## Schwartzwalder Mine Revised AM-06

**Subject:** Response to Secondary Adequacy Review  
Application Amendment #6  
Mine Land Reclamation Permit M-1977-300, Schwartzwalder Mine, Golden, Colorado

M-1977-300 APPLICATION AMENDMENT #6, COMMENT AND RESPONSE SUMMARY TABLE		
COMMENT NO.	COMMENT	RESPONSE TO COMMENT
COLORADO DIVISION OF RECLAMATION AND MINING SAFETY		
1	<p>Exhibit E – Reclamation Plan (Rule 6.4.5):</p> <p>The operator has provided Figure E-2 to address the Division’s adequacy item #3 (from the preliminary adequacy review letter). However, not all components requested were added to the map. Please revise Figure E-2 to include “any significant fracture/fault systems and other potential groundwater migration pathways that intersect the mine workings, and the point at which any such pathways intersect the creek system between the mine site and Ralston Reservoir”.</p>	<p>Please note that in response to this adequacy review, figure numbers have changed, Figure E-2 is now Figure E-4. CLL has updated the map to show locations of the major fault systems as requested, however the groundwater gradients on this figure clearly show that a potential groundwater migration pathway does

**FIGURE E-6**  
**SCHWARTZWALDER MINE IN-SITU TREATMENT -**  
**URANIUM CONCENTRATIONS**

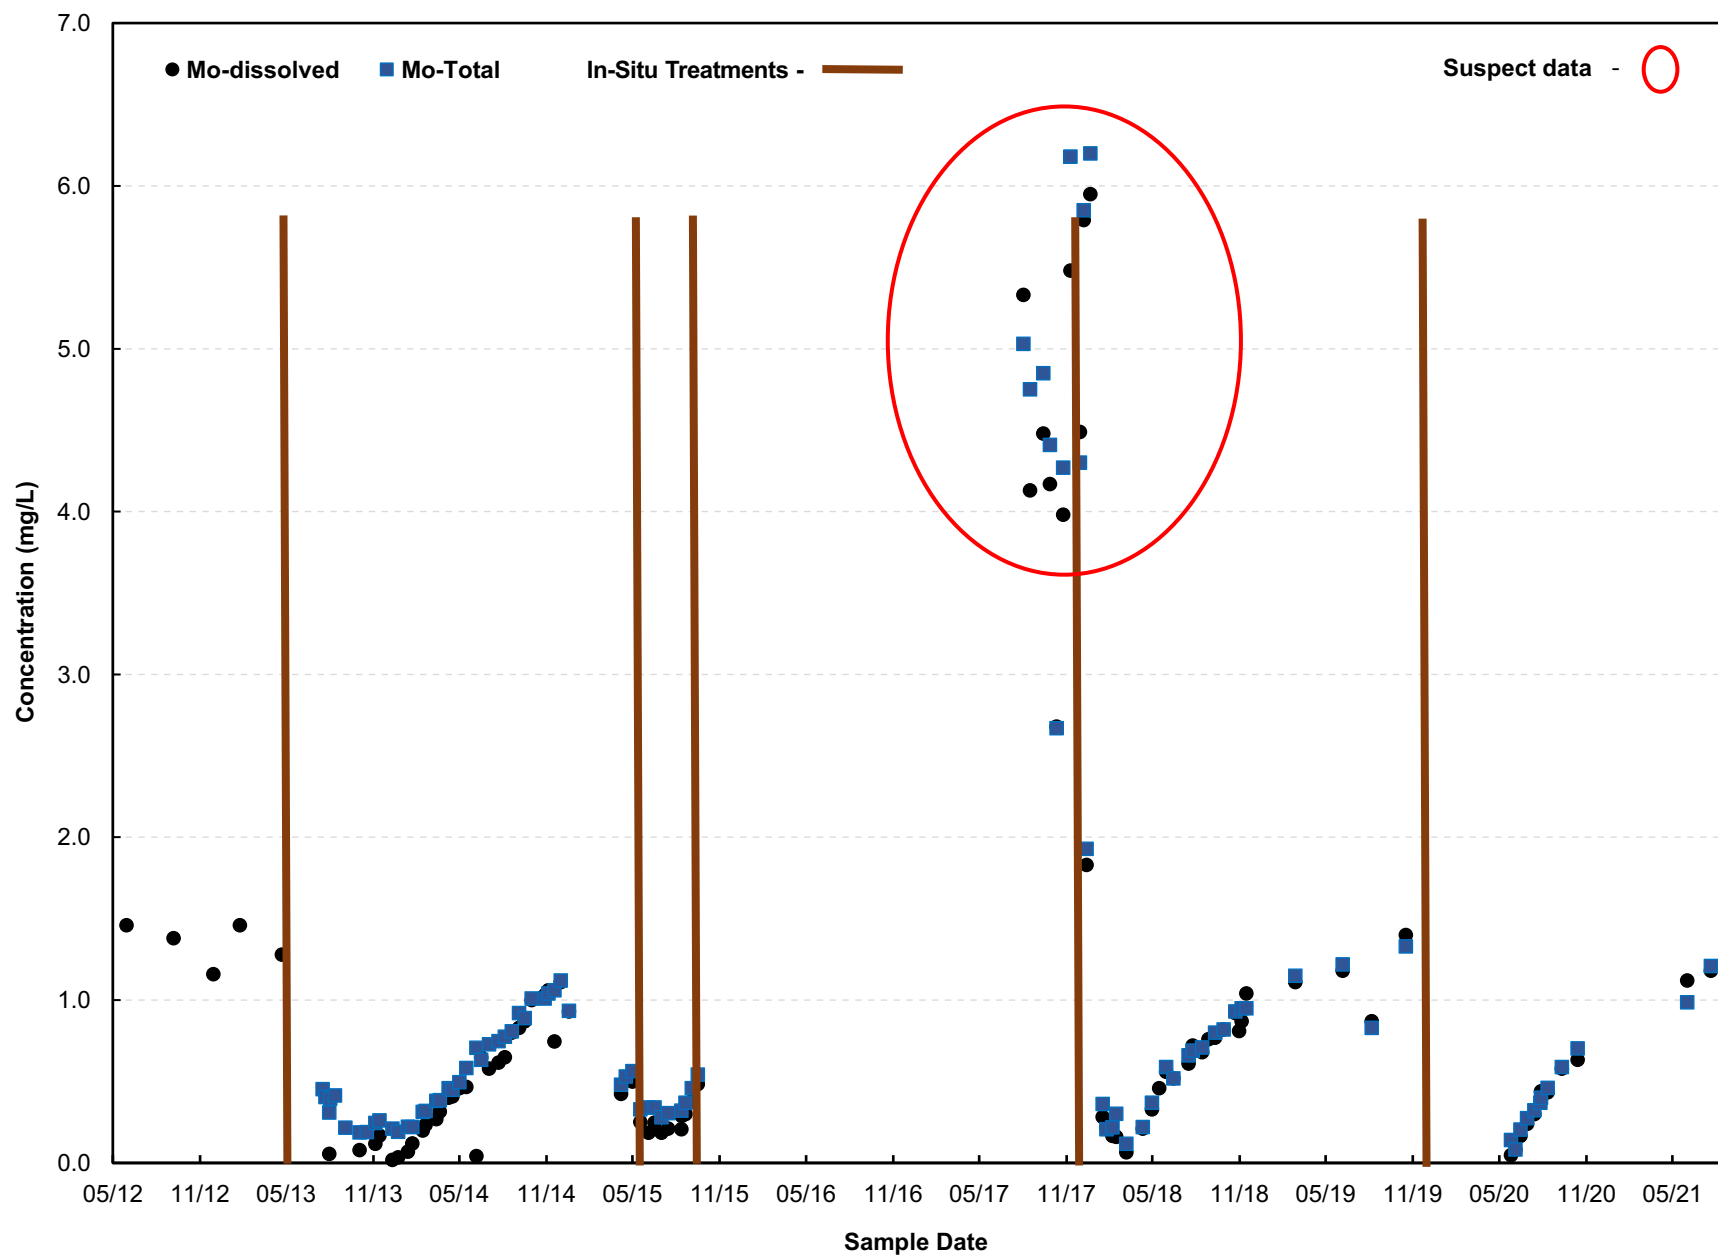
M-1977-300 APPLICATION AMENDMENT #6, COMMENT AND RESPONSE SUMMARY TABLE		
COMMENT NO.	COMMENT	RESPONSE TO COMMENT
8	<p>Exhibit E – Reclamation Plan (Rule 6.4.5):</p> <p>Please provide a detailed plan for removing the master sump for reclamation, including the anticipated disposal location for the materials demolished/removed.</p>	Revised as requested. Sump and well abandonment is discussed in Section E. 6
9	<p>Exhibit E – Reclamation Plan (Rule 6.4.5):</p> <p>Please describe the existing mine closures (and/or provide photographs of each closure) installed in the following mine openings: Minnesota Adit, Sunshine Decline, Steve Adit, CV/Charlie Adit, and Pierce Adit.</p>	Revised as requested. Photos of each mine opening closure have been added to Exhibit E as Figure E-1.
10	<p>Exhibit E – Reclamation Plan (Rule 6.4.5):</p> <p>In comparing the recent mine pool chemistry (2018-present) to the mine pool chemistry during the period when the mine workings were flooded (2000-2007), the operator states that bulk TDS of the mine water has not changed, indicating the mine is chemically stable. Please provide a graph showing available TDS data compared with Uranium concentration data for these two periods. Additionally, please add TDS data on either the revised Figure E-4 or E-7.</p>	Please note that in response to this adequacy review, figure numbers have changed, Figure E-4 is now Figure E-6 and Figure E-7 in now Figure E-9. Instead of creating another figure as requested, CLL has added the TDS data to Figure E-6 (formerly E-4) to respond to this request.

Also shown on Figure E-6 are the TDS concentrations. Except for the noted period of suspect data, the TDS concentrations have been generally stable. This stability supports the viability of the RO technology treatment system, which is discussed in Section E.5.2.4.

FIGURE E-7  
SCHWARTZWALDER MINE IN-SITU TREATMENT -  
MOLYBDENUM CONCENTRATIONS

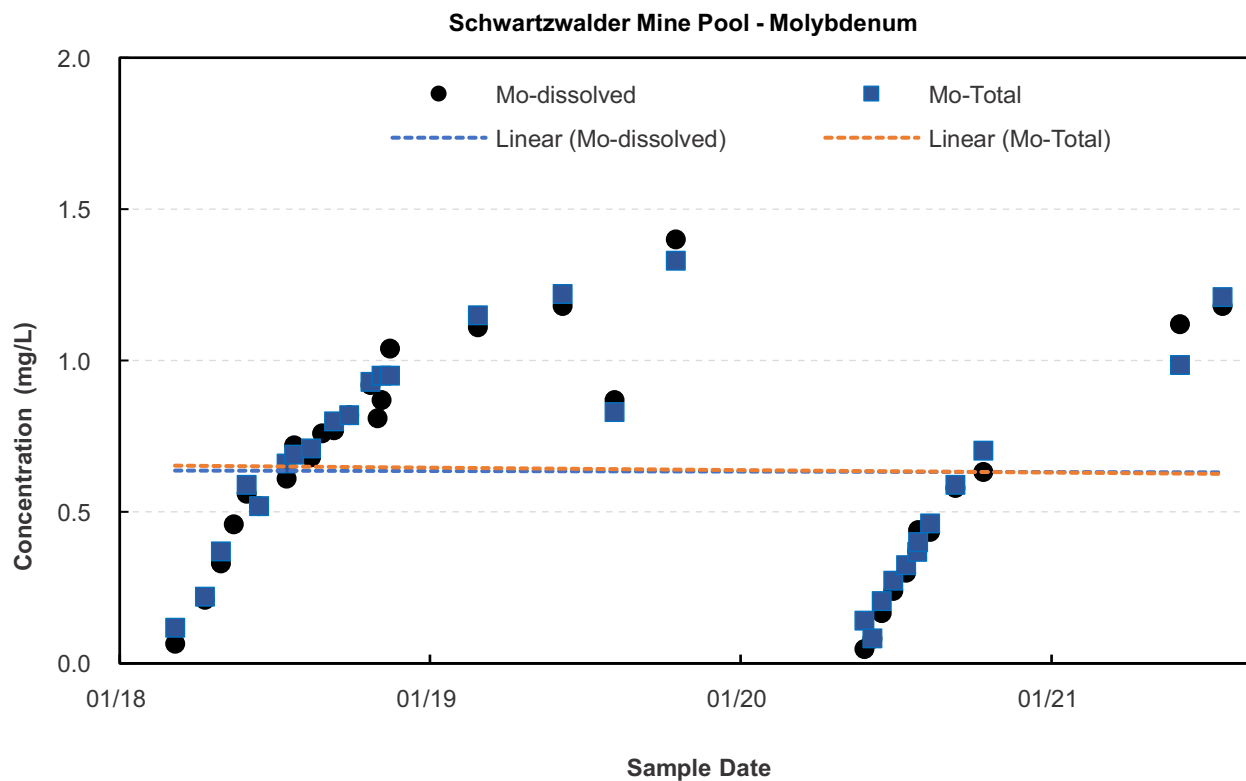
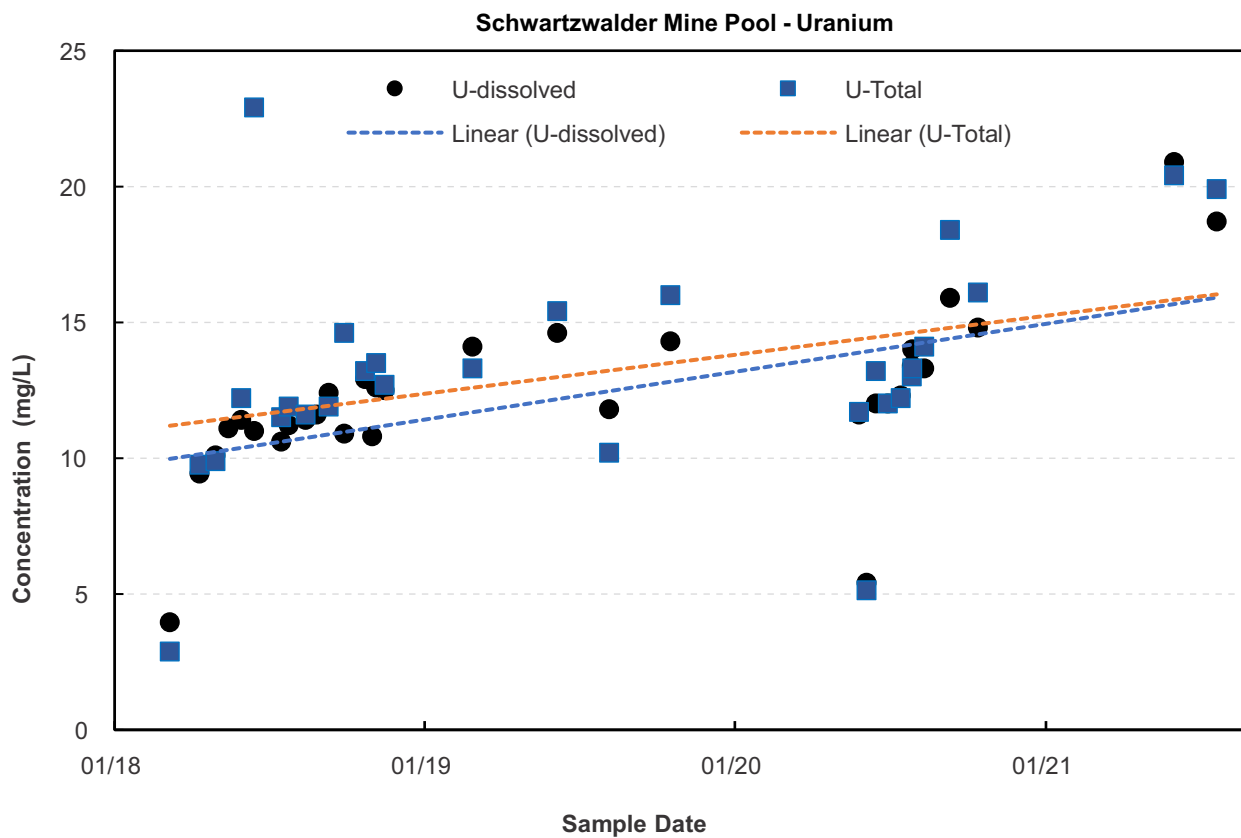
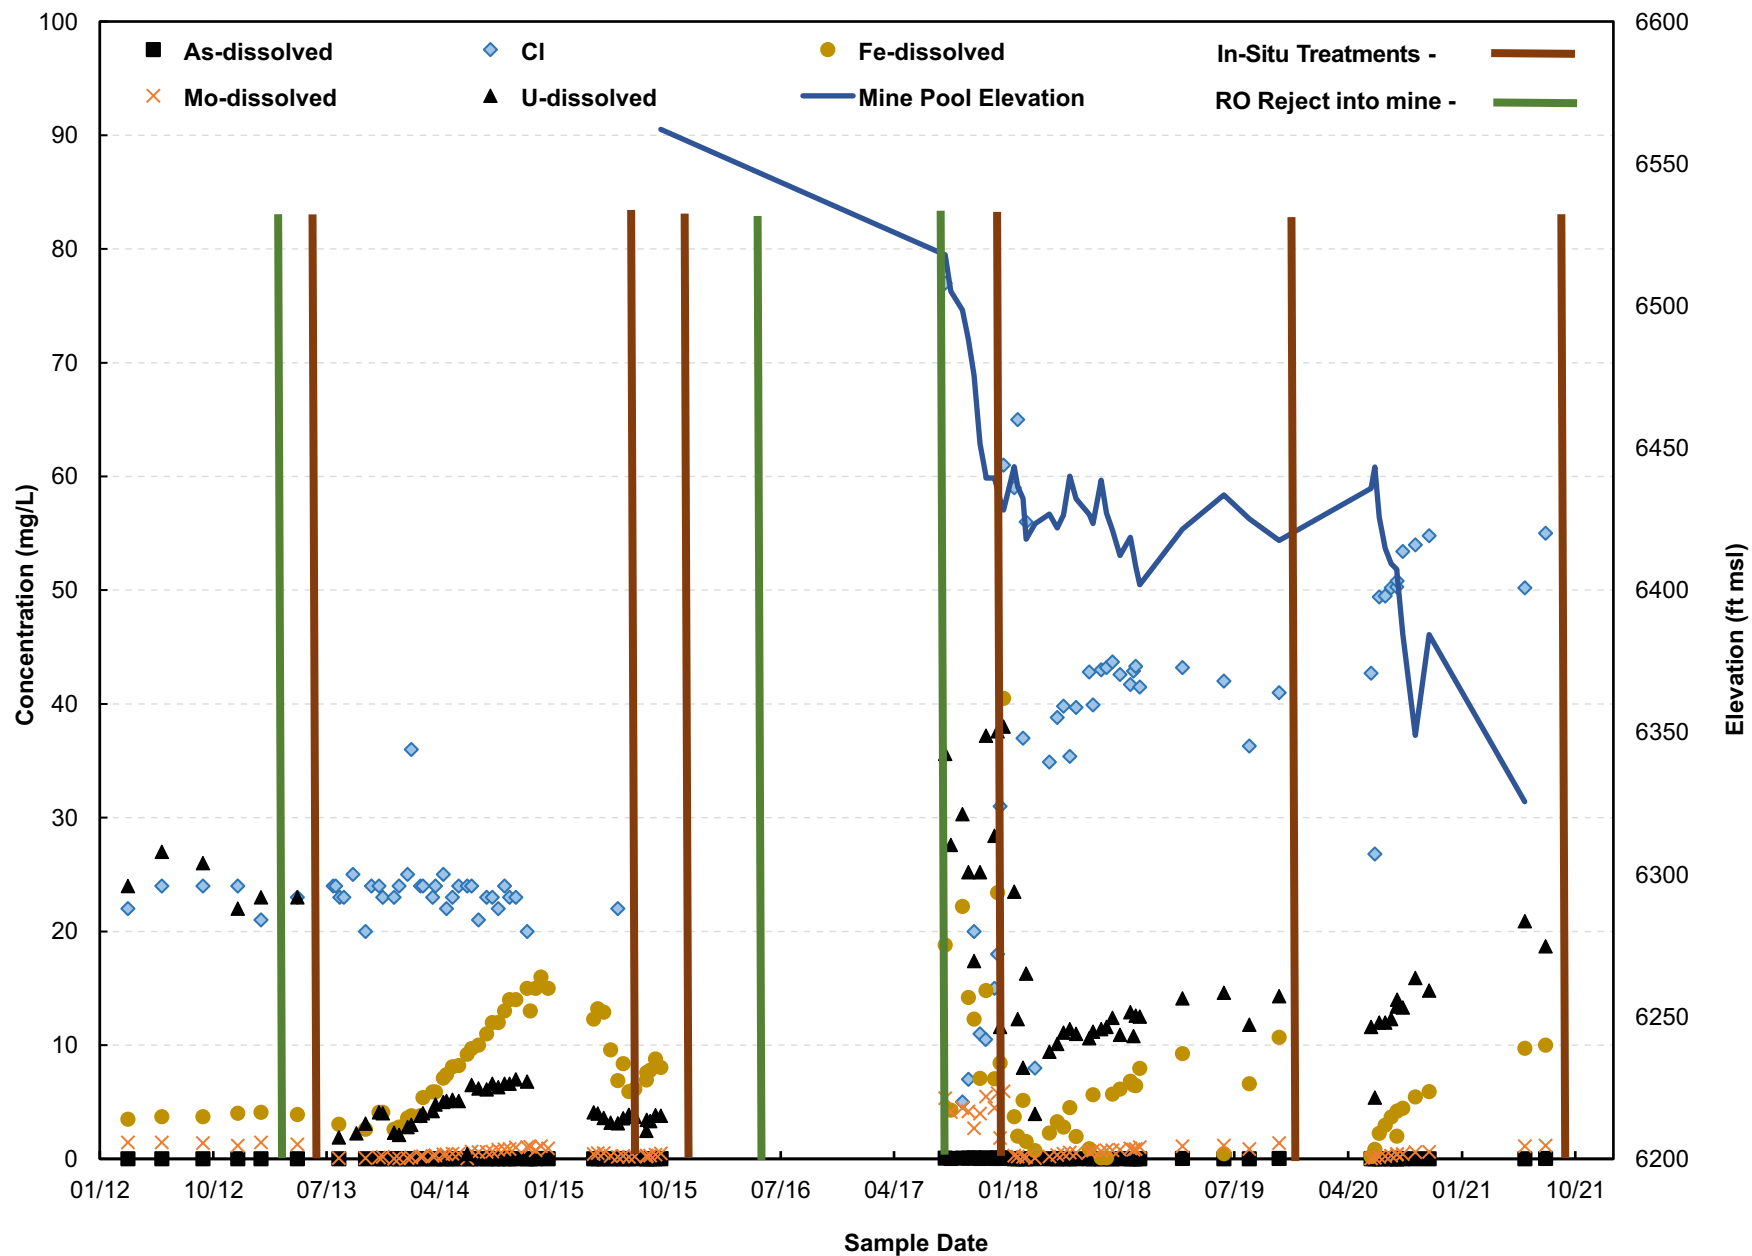
12	<p>Exhibit E – Reclamation Plan (Rule 6.4.5):</p> <p>On the revised Figure E-7, the operator has included the points in time in which RO reject was injected into the mine, the last of which occurred in 2017. It is the Division’s understanding that RO reject is injected into the mine when the water treatment plant is in operation. If this is correct, there should be four additional times between 2018 and 2021 during which, RO reject was injected into the mine. Please provide clarification on this matter and add additional information to this figure, if needed.</p>	<p>Please note that in response to this adequacy review, figure numbers have changed, Figure E-7 is now Figure E-9.</p> <p>In the previous comments, the request was <i>“Please include available mine pool elevation data, dates for in-situ treatments, and <b><u>the date the operation began injecting RO reject brine into the mine pool</u></b>.”</i> (emphasis added) As requested, CLL added the 2 occasions (2012/2103 and 2016) that RO reject brine was injected into the mine pool and when the continuous operation and injections started in mid-2107. Rather than clogging up the figure with additional vertical lines, CLL has made a note on the figure to indicate that beginning in mid-2107 the RO reject brine has been continuously injected into the mine pool during operation of the treatment plant. Please note that the text already provided this explanation in the previous version.</p>

A reclamation plan map is shown on Figure F-1.

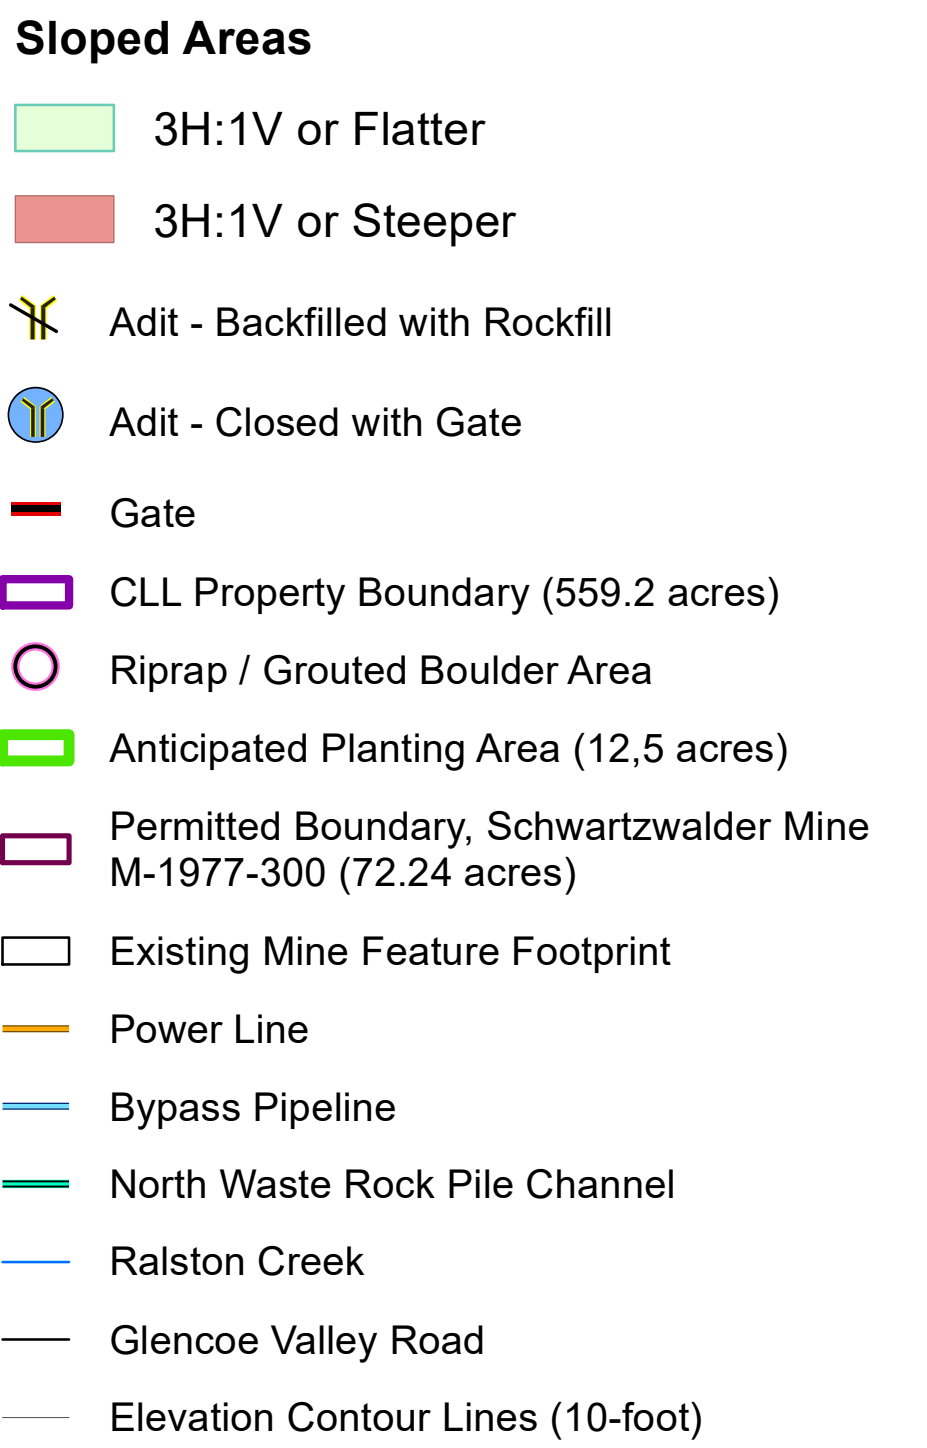
16	<p>Exhibit F – Reclamation Plan Map (Rule 6.4.6):</p> <p>The Division has the following comments on the Figure F-1 Reclamation Plan map provided:</p> <p>a. Please explain the “diversion structure” shown to remain along the southern edge of the creek. Is this structure meant to represent the existing bypass pipeline? If so, please remove it from this map as the proposed reclamation plan includes removing this pipeline for reclamation. If this structure represents something else, additional clarification on the map is needed to differentiate it from the NWRP stormwater diversion channel (also identified on the map as “diversion structure”)</p> <p>b. Please identify the areas to receive each of the revegetation plans proposed for reclamation.</p> <p>c. Please ensure all structures proposed to remain for reclamation (e.g., upgradient cutoff wall, riprap/grouted boulder areas, bridges, culverts, wells, buildings, powerlines, pipelines, roads, graveled or paved parking areas) are shown on this map.</p> <p>d. Please show the location of the Jeffrey Air Shaft and any structures currently installed at the surface of this shaft which are proposed to remain for reclamation.</p>	<p>a. Yes this “diversion structure” was the Ralston Creek bypass pipeline and North Waste Rock Pile channels. The legend of the figure has been revised for clarity. The text in AM-06 has been revised so it’s clear that CLL intends to leave the bypass pipeline and associated infrastructure in place at least until it has been confirmed that surface water flow across the reclaimed site does not create an exceedance of uranium at BPL.</p> <p>b. At this time CLL cannot identify the exact area’s that will receive each of the revegetation plans (seed mix, trees, and shrubs) because the extent of the alluvial valley reclamation project is not known. CLL shall prepare a site-specific planting plan in coordination with DRMS, USACE, and USFW once the excavation project is complete. Figure F-1 has been revised to illustrate the anticipated planting area, which corresponds to disturbed surface features at the site. CLL expects this disturbed area to receive the majority of the revegetation planting, however planting may extend to other areas along Ralston Creek within the Mine Permit Boundary.</p> <p>c. Revised as requested.</p> <p>d. Revised as requested. The insert showing the water treatment plant infrastructure has been updated to show the Winch and Cable Housing for the Dewatering Pump, which is installed in the Jeffery Air Shaft.</p>
